UNIVERSITY OF WISCONSIN  
NUCLEAR REACTOR  
LICENSE NO. R-74  
DOCKET NO. 50-156

RESPONSE TO REQUEST FOR ADDITIONAL  
INFORMATION REGARDING HEU/LEU  
CONVERSION

Subject: Docket 50-156, License R-74  
Response to Request for Additional Information  
for Amendment No. 17 to Facility License No. R-74  
University Of Wisconsin Nuclear Reactor  
TAC No. MD9592

## Responses to LEU Conversion Request for Additional Information

Figure RAI-2-1, UWNR Core Lifetime

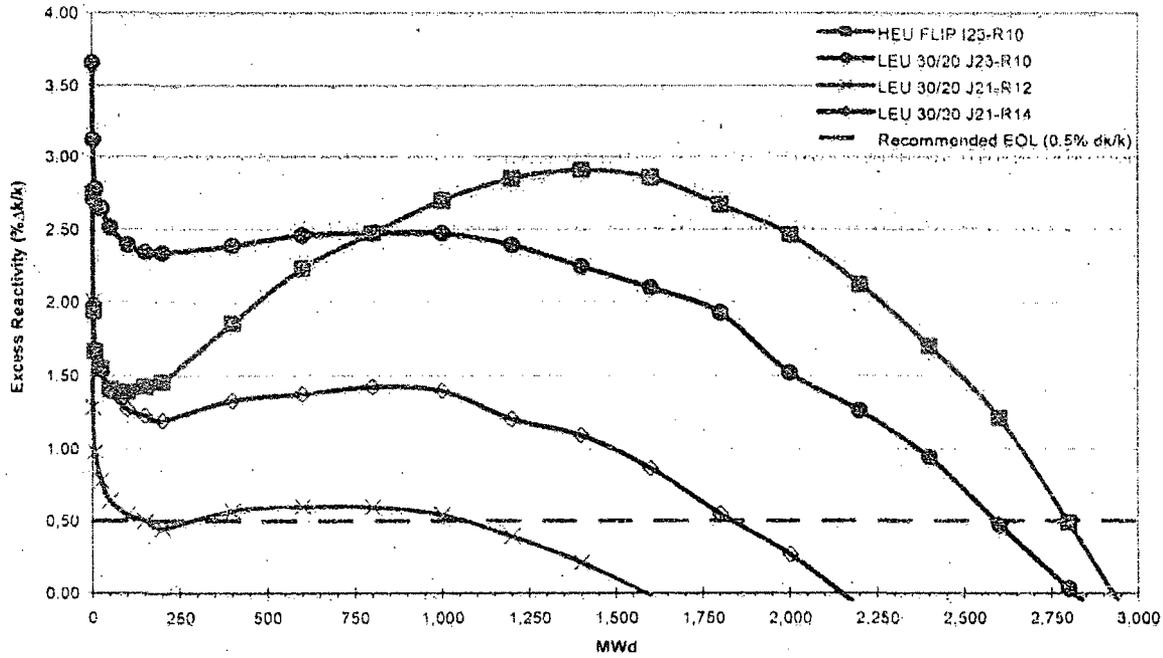
2. Sections 1.1, 1.3, 4.2.2, and 4.2.3. In Section 1.1 and 1.3, your application states that only the fuel and new fuel storage will be changed as part of the conversion, however in Section 4.2.3 you state four additional reflectors will be installed.

a. Are additional reflectors being added as part of the conversion? If so, please provide justification.

Yes. Four additional reflectors are necessary as part of the conversion. As described in section 4.5.2 (pages 37-38), a reduction in the number of fuel bundles, from 23 to 21, is necessary to ensure shutdown margin. One of the current approved HEU operational cores uses 12 reflectors (I23-R12), so a proposed LEU core was analyzed with 12 reflectors (J21-R12). However, as shown in figure RAI-2-1 below, a much reduced core lifetime would result when compared to the HEU core. Calculations show that the core lifetime of 150 MW-days (with subsequent recovery out to 1100 MW-days) using 12 reflectors can be increased to 1800 MW-days using 2 additional reflectors for a total of 14 reflectors.

Figure RAI-17-1, E3 NE Peak Radial Temperature Distribution

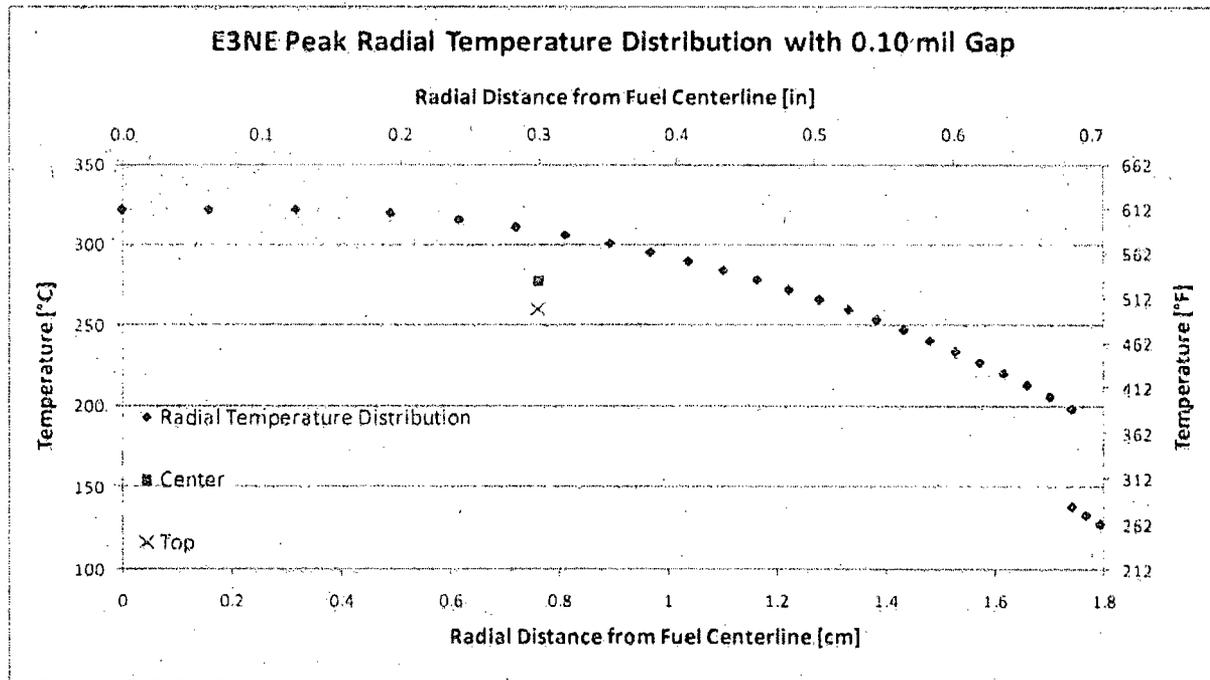
17. Section 4.7.4. In Figure 4.2.1, the location of one instrumented fuel element is shown as E3 NE. The title of Figure 4.7.10 indicates that the instrumented fuel element may have moved from E3 NE to E4 SE for these temperature measurements. Please explain.

During startup testing with the all TRIGA-FLIP HEU core, the fuel temperatures in one quarter of the core were measured as reported in the HEU 2000 license renewal SAR, page 4-45. These measurements were done in support of the reload and startup testing. Once startup testing was complete, the operational core was chosen to have IFEs located in D4 SW and E3 NE. In the analysis report it was chosen to compare the model with a pin having a similar peaking factor which was not the case for E3 NE. Therefore, E4 SE was chosen because both the model and the measured peaking factors were 1.10 as described on page 73.

However, data for E3 NE is available and the measured vs. predicted curve for the instrumented fuel element at E3 NE is shown in the figure below. The bottom thermocouple measurement was not reported in the reload report due to the thermocouple burning out during startup testing.

Figure RAI-22-1, Coolant Flow Rate vs. Power LEU-BOL

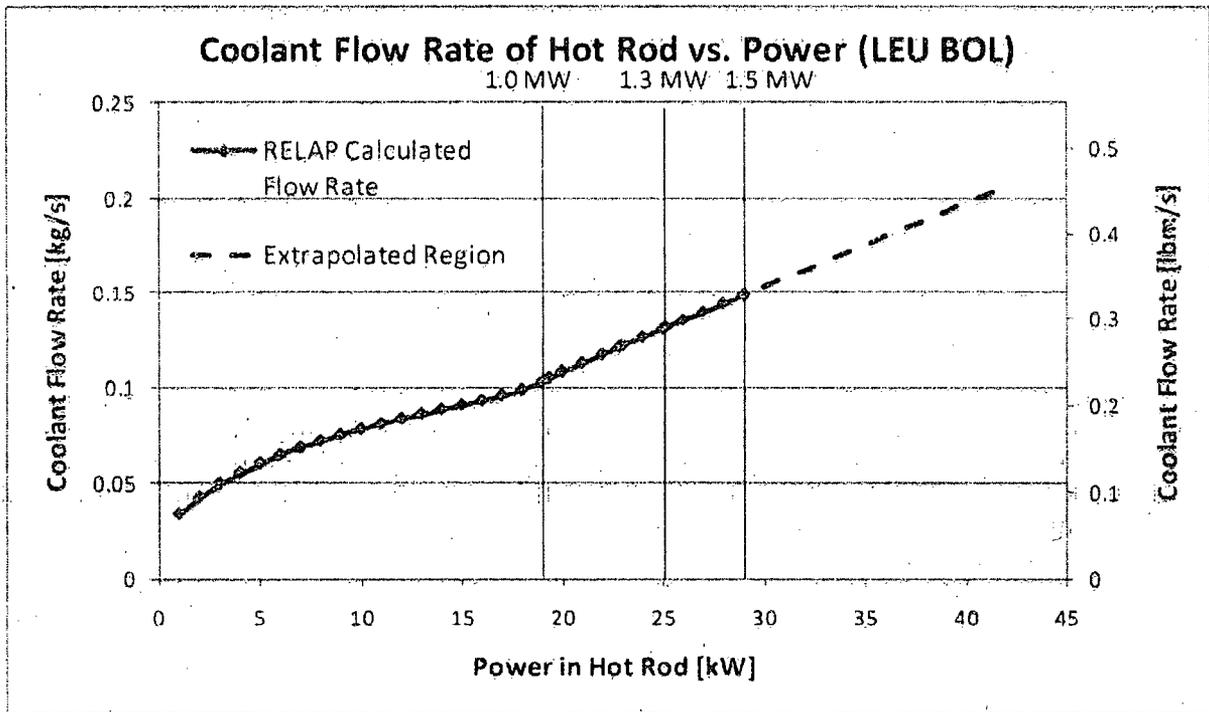
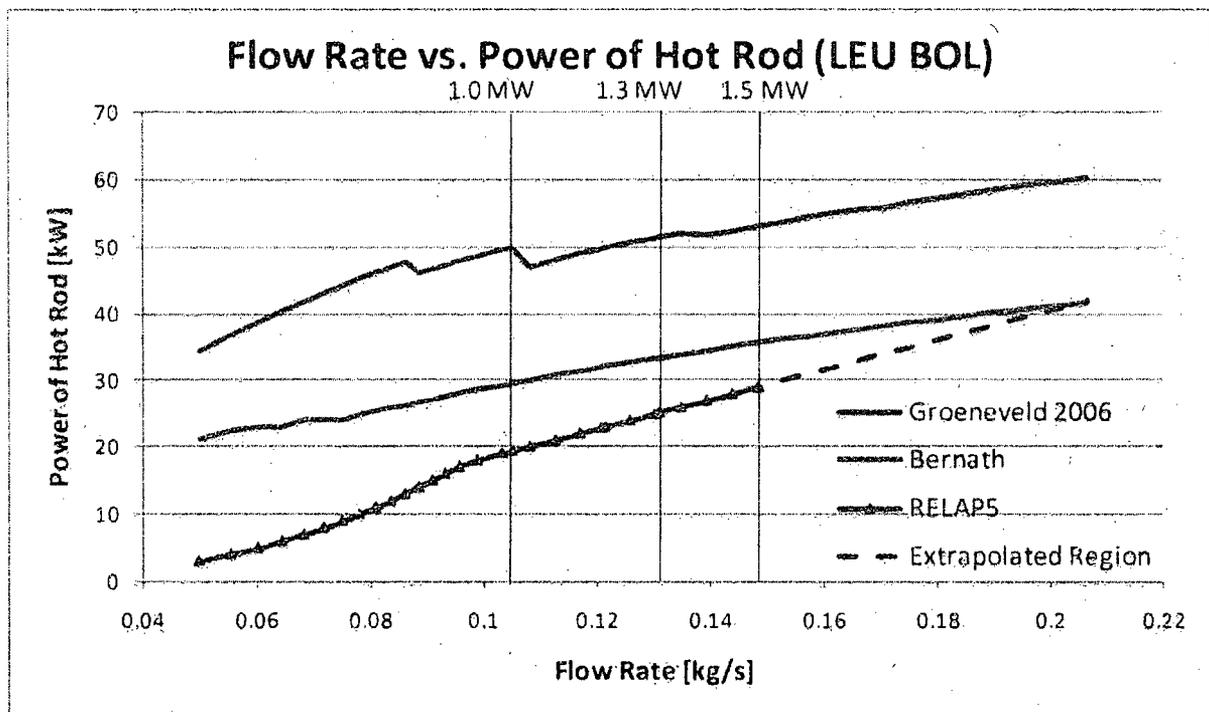
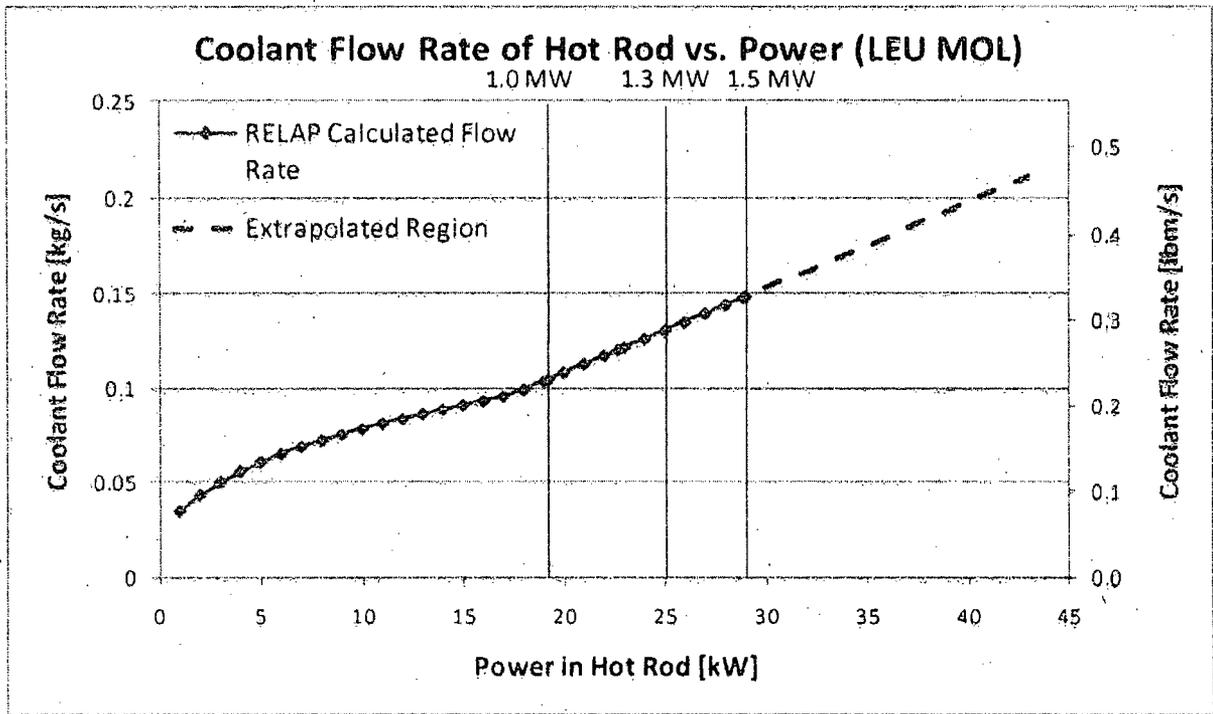
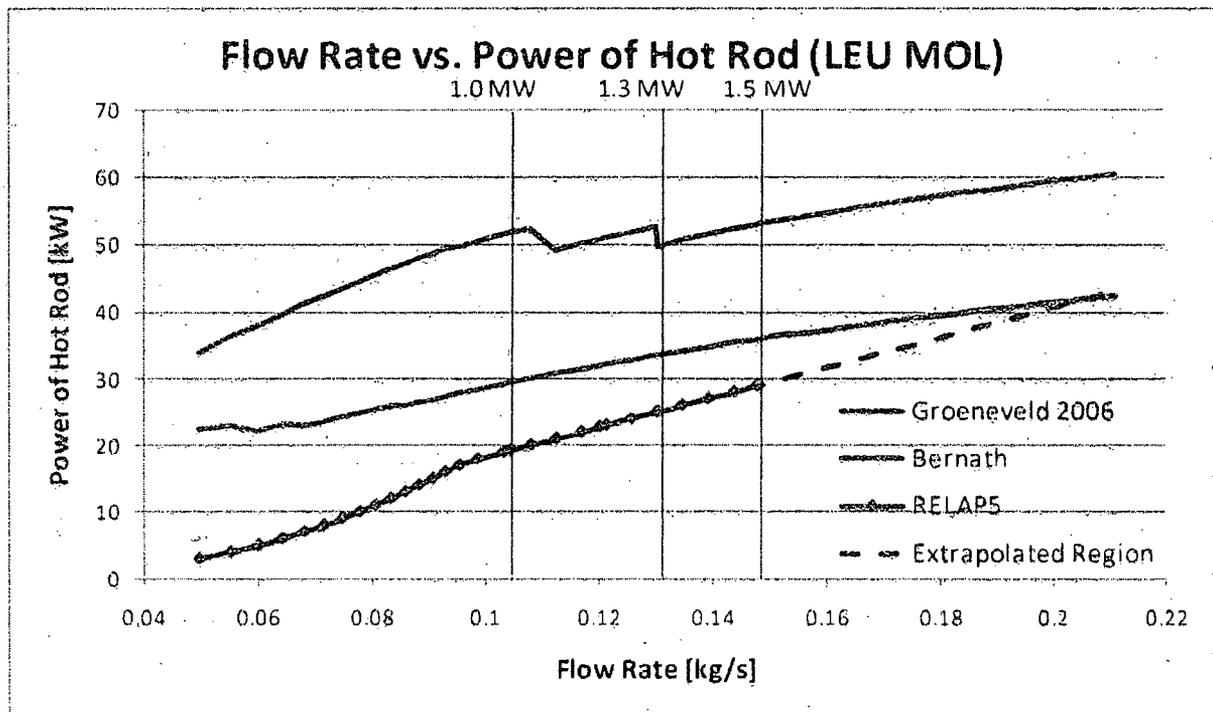
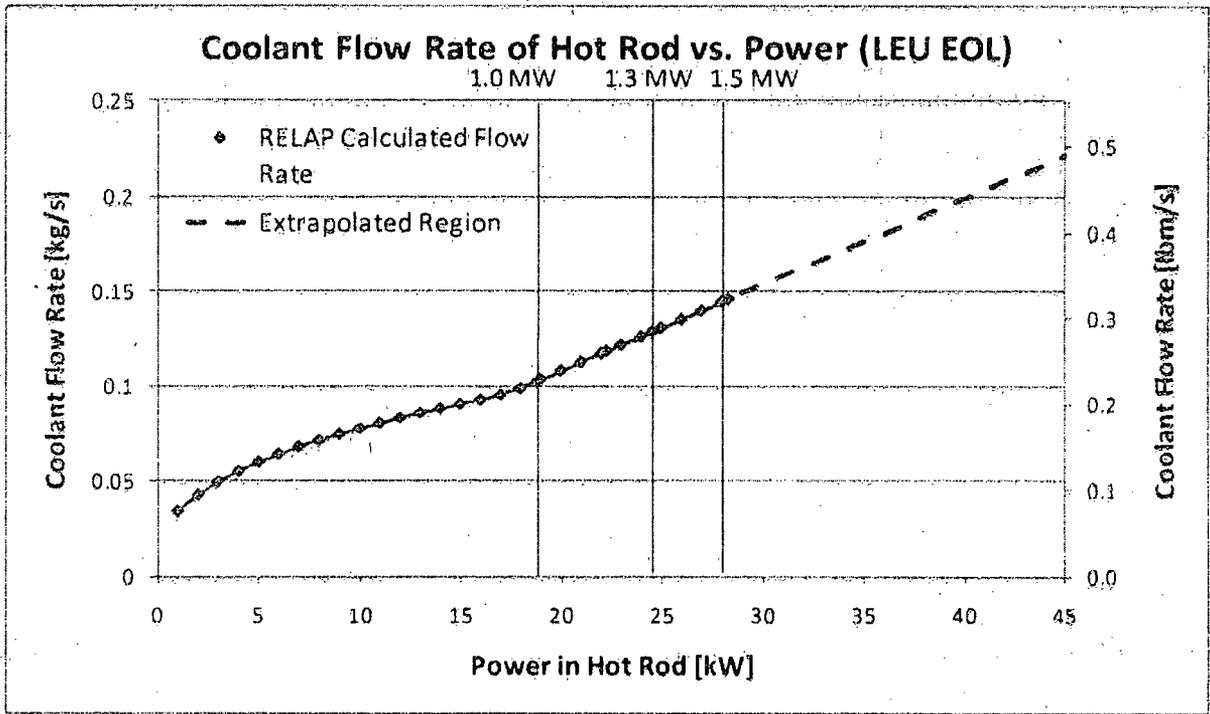
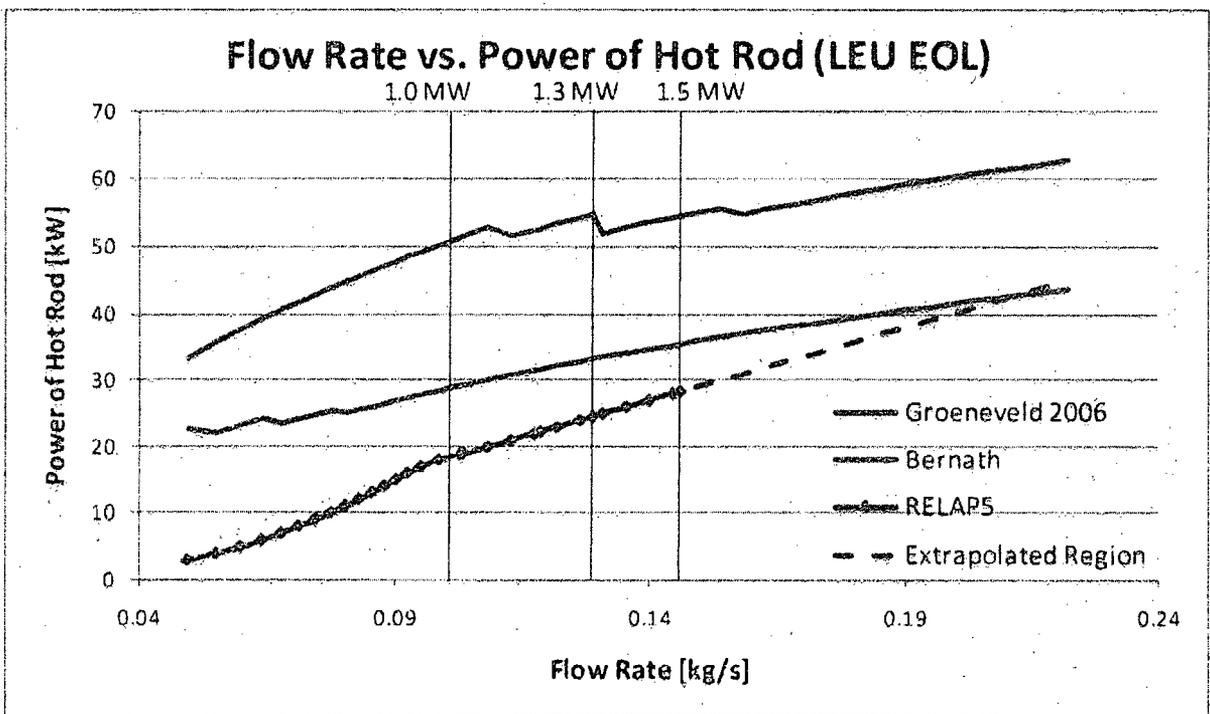
22. Section 4.7.4, 4.7.7, 4.7.8, and 4.7.9: When you calculated coolant flow rate versus hot rod power for various core configurations, RELAP5 calculated flow oscillations at some power. Above this hot rod power, you provide graphs showing projections of coolant flow rate. Is the extrapolation of flow calculated by RELAP5 above the last predicted stable flow realistic? Please discuss.

The normal steady state method of solving the RELAP5/MOD3.3 transient failed to get a stable solution for core powers around 1.5 MW. However, another method of solving the steady state cases using a 'pseudo transient' was used that was able to extend the RELAP5/MOD3.3 region of applicability before having to use the extrapolated region. By setting the initial mass flow rate to nearly zero and setting the power to nearly zero and then ramping up the power until RELAP can calculate a steady state solution produced the following graphs for LEU-BOL, MOL and EOL. The revised axial and radial power distributions for LEU-BOL were used.

The direct answer to the question "Is the extrapolation of flow calculated by RELAP5/MOD3.3 above the last predicted stable flow realistic?" is that it is simply not known. It may be possible that stable subcooled nucleate boiling flow occurs considerably above the powers that RELAP5/MOD3.3 predicted, but without applicable experimental data it would be difficult to say with certainty. Anderson, et al from the University of Wisconsin has proposed to ANL to precisely determine CHF for the three TRIGA fuel assembly types (hexagonal, circular and rectangular). However, it is important to emphasize that a reactor power of 1.5 MW with an inlet temperature of 54.44°C is far beyond not only normal operating conditions at 1.0 MW with about a 30°C inlet coolant temperature, but also the anticipated faulted conditions where the power trip is no higher than 1.3 MW.
